## **HILLWOOD SUBDIVISION, RESUBDIVISION OF LOT 1, REVISED**

APPLICATION NUMBER 1 DATE February 1, 2007  
APPLICANT Hillwood Subdivision, Resubdivision of Lot 1, Revised  
REQUEST Subdivision

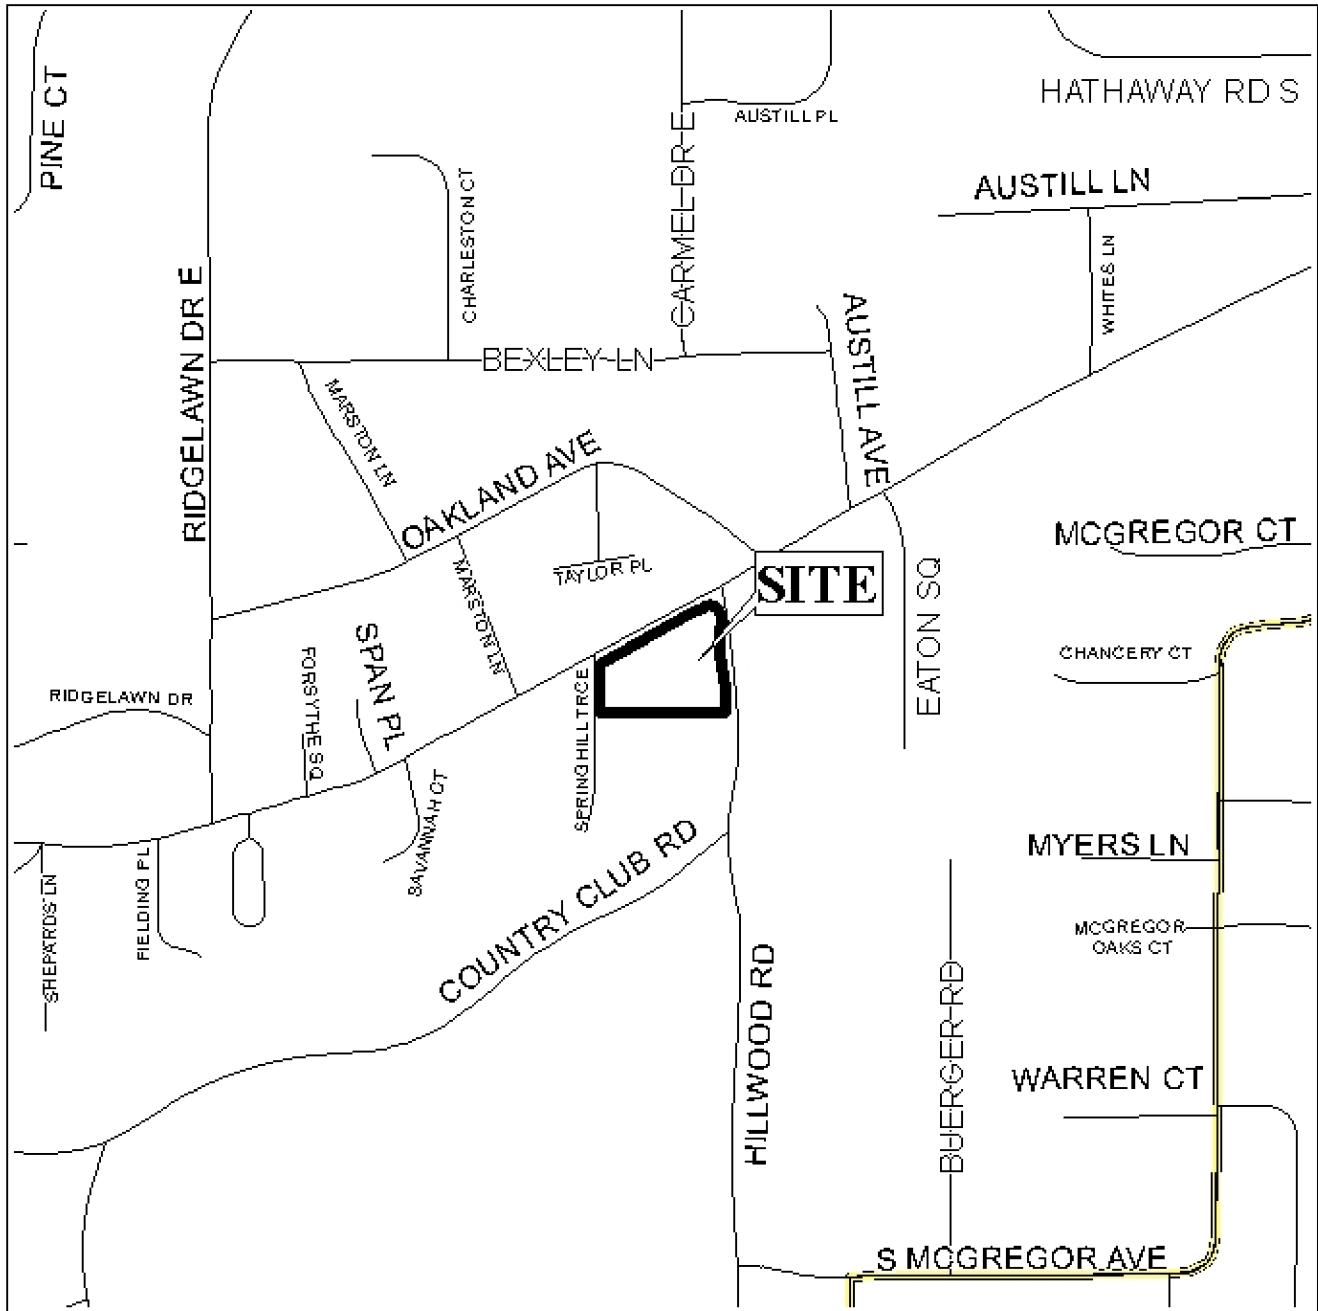
The plat illustrates the proposed 1.7± acre, 2-lot subdivision which is located on the Southwest corner of Old shell Road and Hillwood Road, and is within Council District 5. The applicant states that the subdivision is served by both public water and sanitary sewer.

Access management is a concern due to the site's location at a corner and due to the daily traffic count along Old Shell Road. The placement of a note on the Final Plat stating that Lot A should be limited to the existing curb-cut onto Hillwood Road, and Lot B the existing curb-cut onto Old Shell Road, with the size, design and location to be approved by Traffic Engineering, and in conformance with AASHTO standards.

The plat meets the minimum requirements of the Subdivision Regulations and is recommended for Tentative Approval, subject to the following conditions: 1) the placement of a note on the Final Plat stating that Lot A is limited to the existing curb-cut onto Hillwood Avenue and Lot B is limited to the existing curb-cut onto Old Shell Road, with the size, design to be approved by Traffic Engineering, and comply with AASHTO standards; 2) labeling of the lot with its size in square feet, or provision of a table on the plat with the same information; and 3) full compliance with all other municipal codes and ordinances.
